01-AFC-4
CALIF ENERGY COMMISSION

May 7, 2001

Subject: East Altamont Energy Center Application for Certification
Data Adequacy Response Set 3

EAST ALTAMONT ENERGY CENTER DATA ADEQUACY RESPONSE SET 3

Table 4 -2005 HS Case with EAEC, **Two Lines** from EAEC to Westley Elverta-Foothill Outage

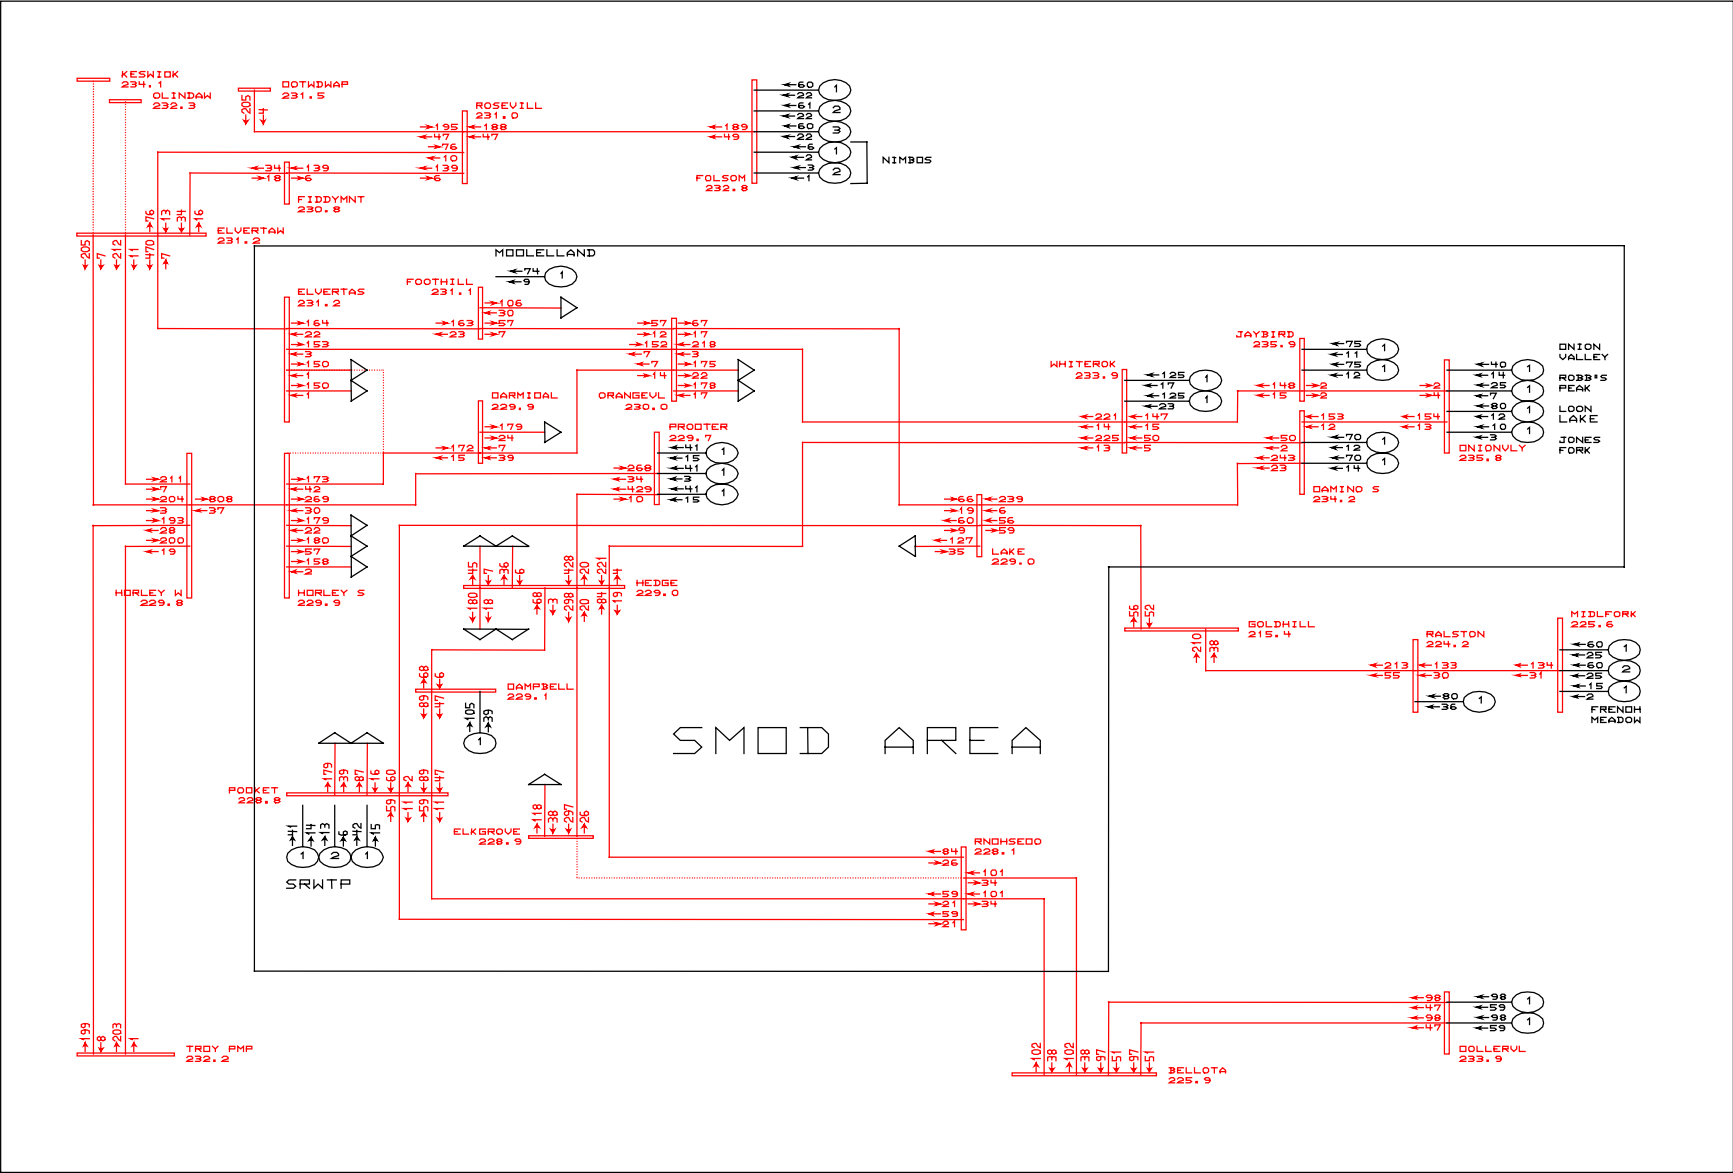
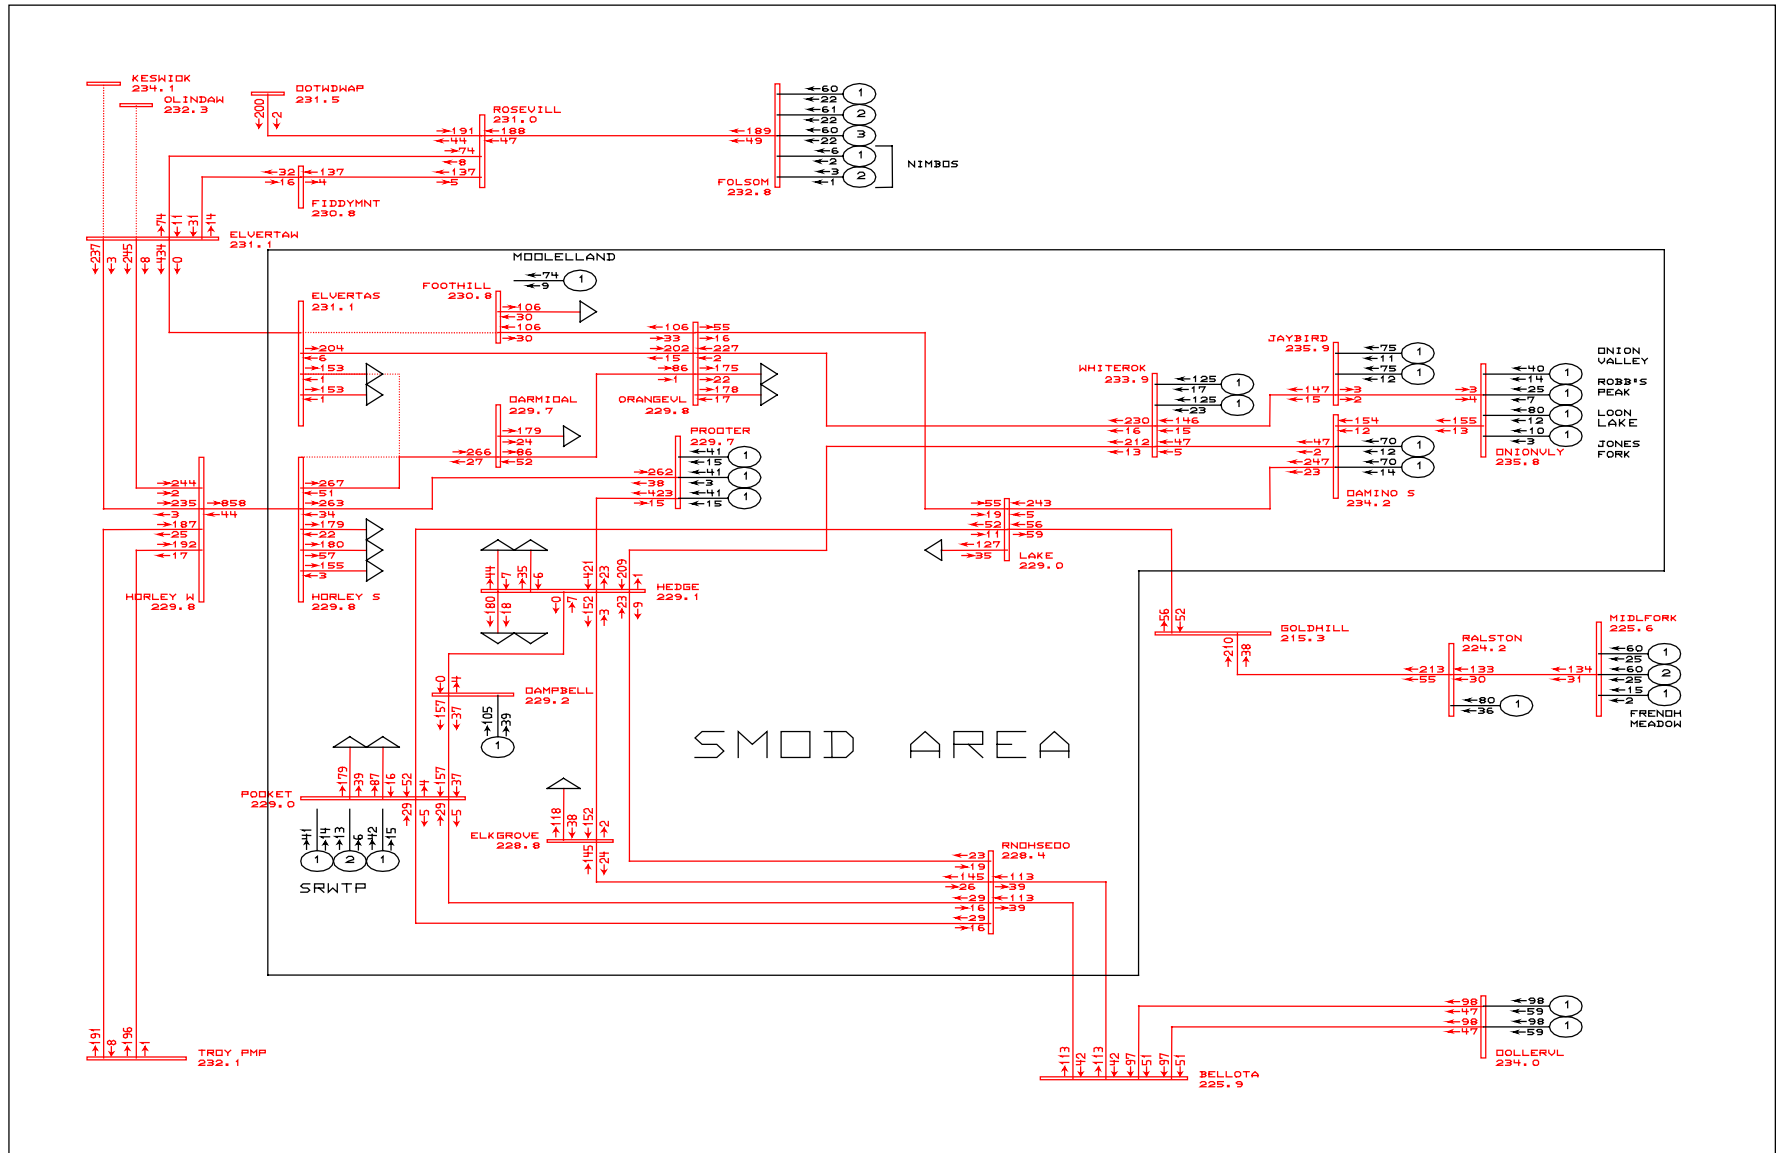
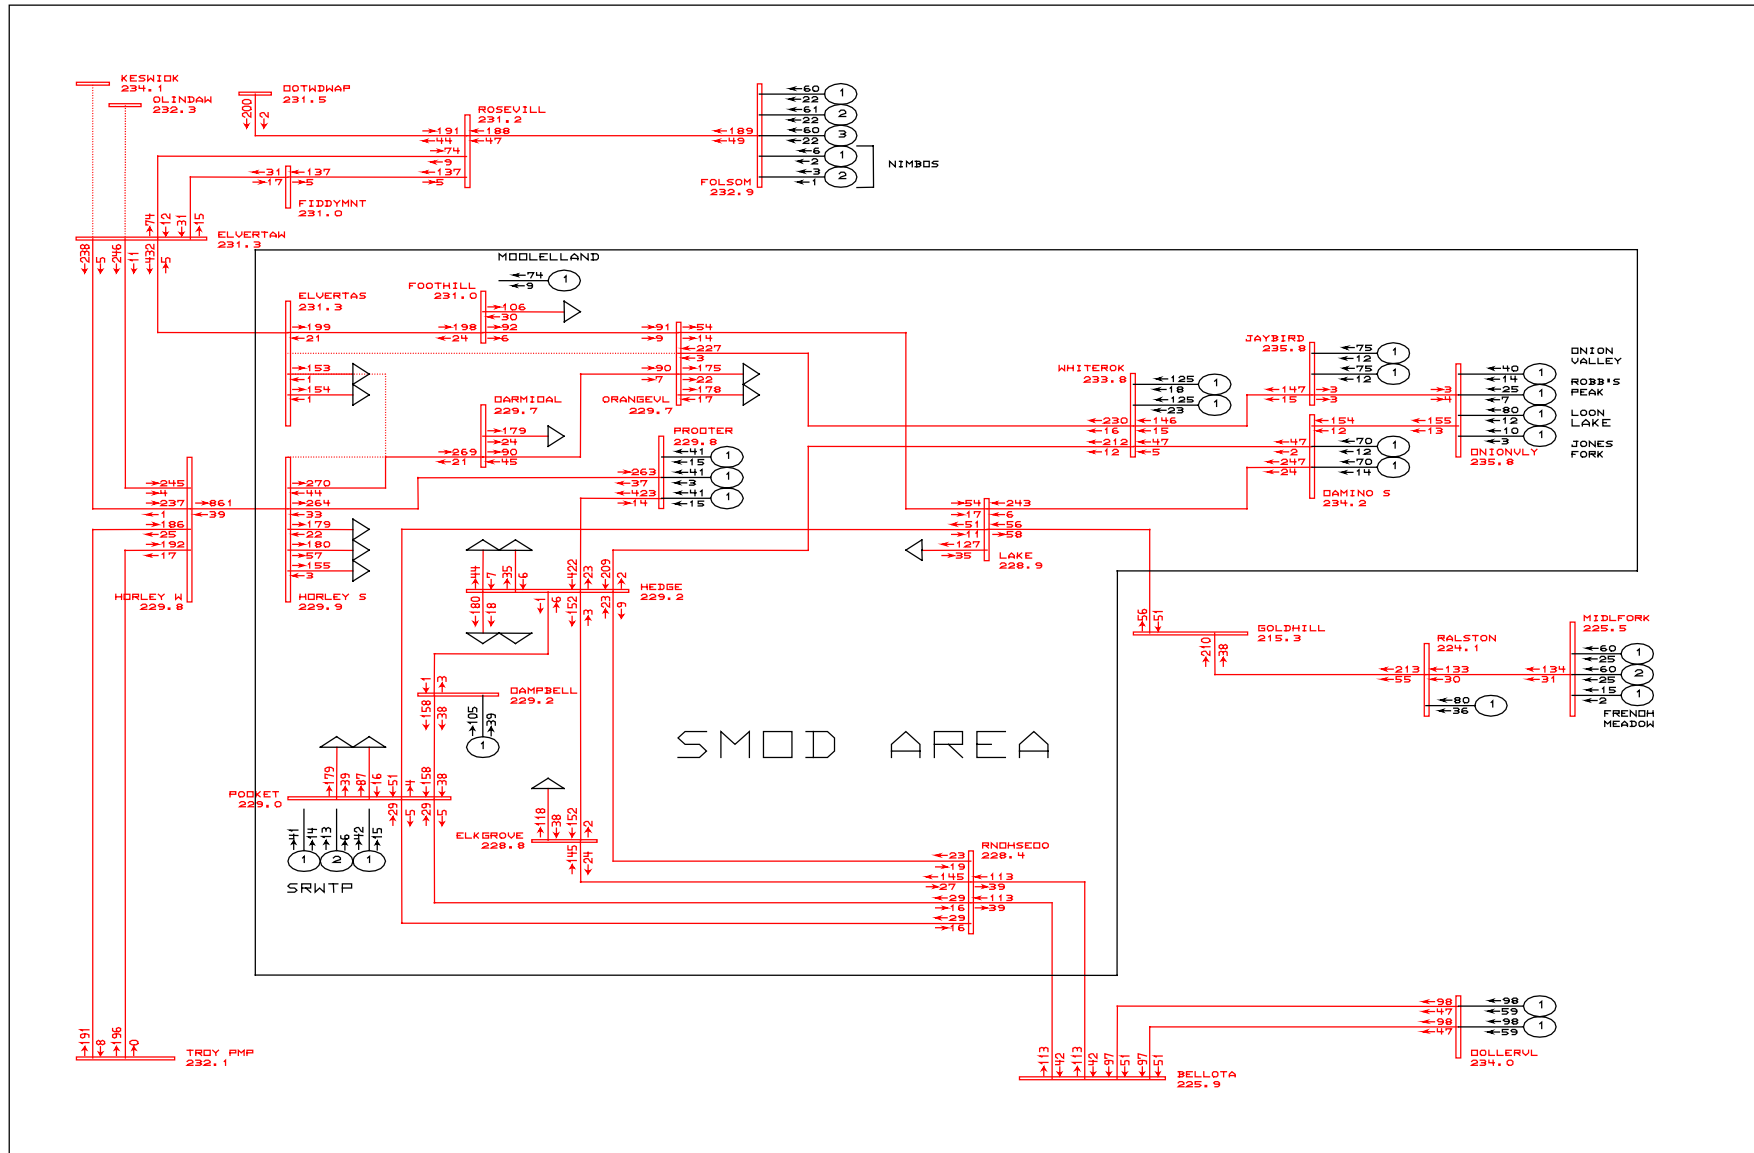
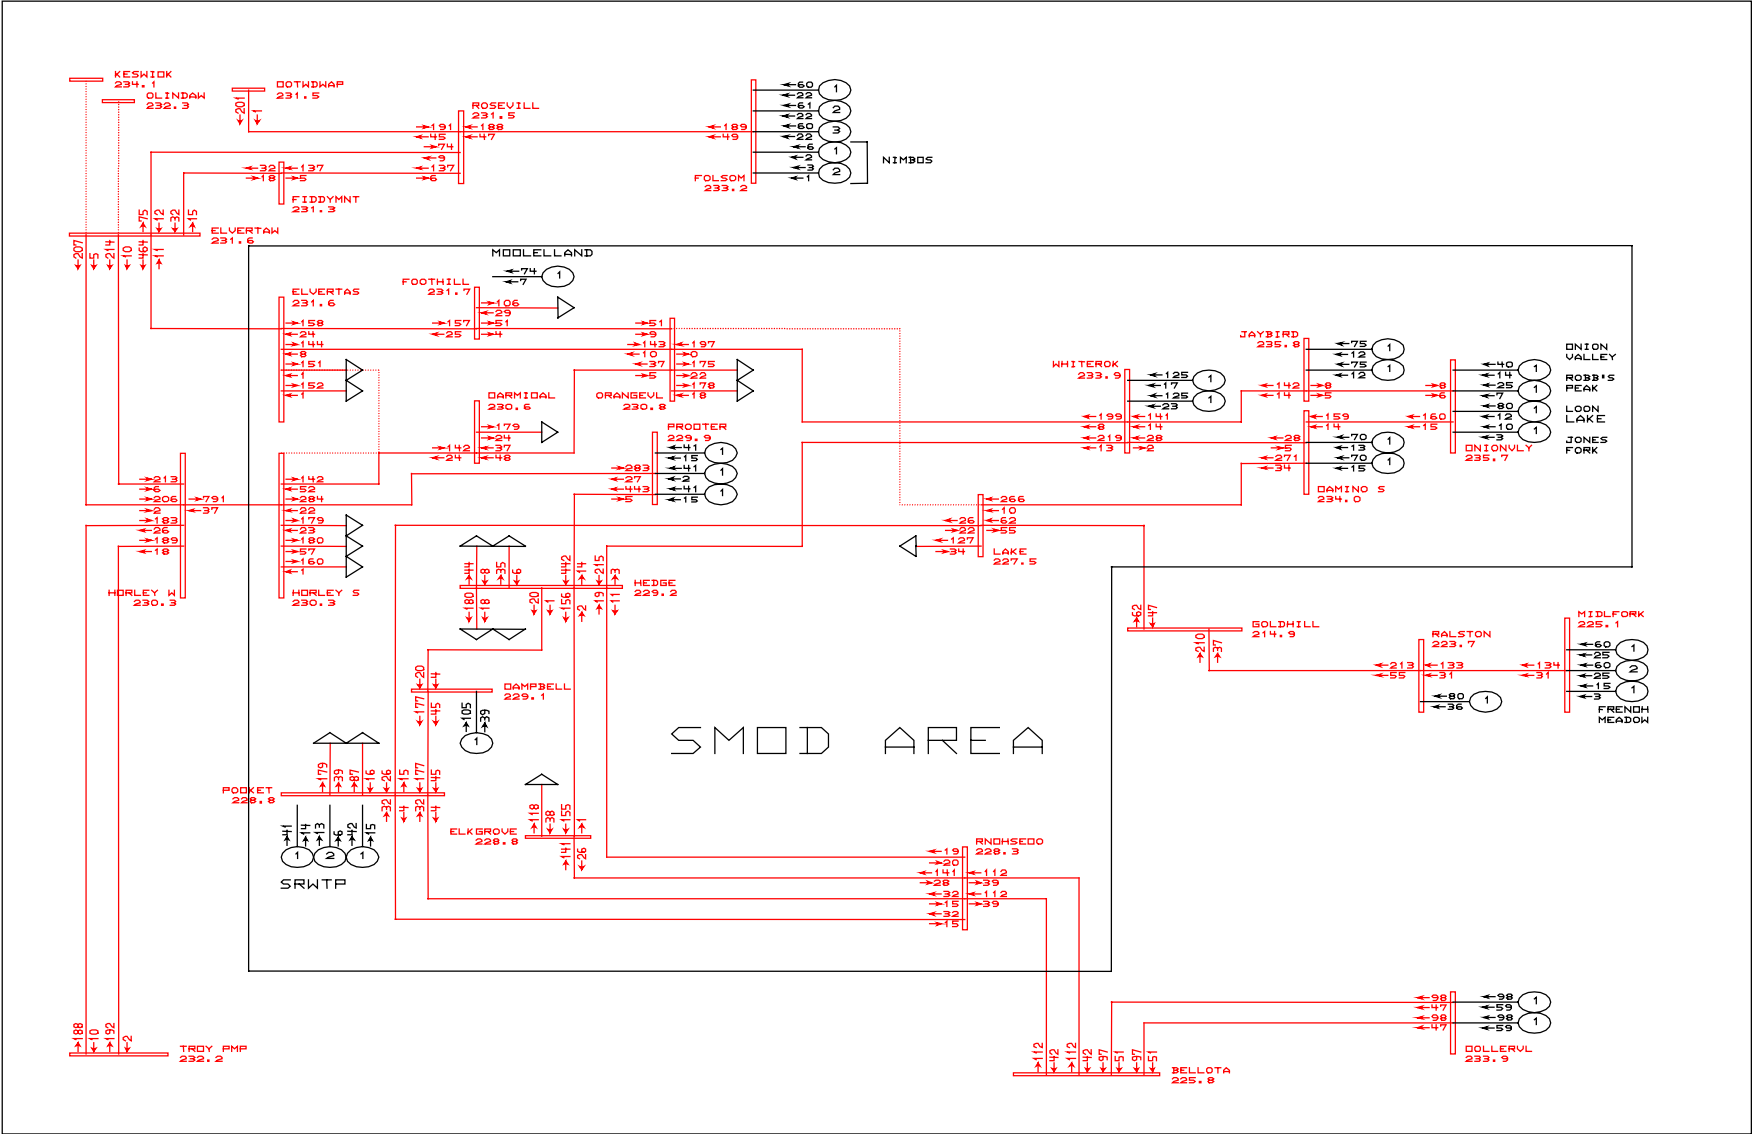
Data Adequacy Deficiency – Provide power load flow diagrams which demonstrate conformance or non conformance with utility reliability and planning criteria.

Provide a System Impact Study per the study plan of Appendix 5.4-A.

Data Adequacy Response – The power load flow diagrams prepared by Western Area Power Administration are attached as TSE-2. The attached power flow drawings are drawings of the base cases and the outages for each of the cases, which correspond to Tables 2, 3 and 4 in the System Impact Study submitted on May 2 in EAEC LLC's Data Adequacy Set 1.
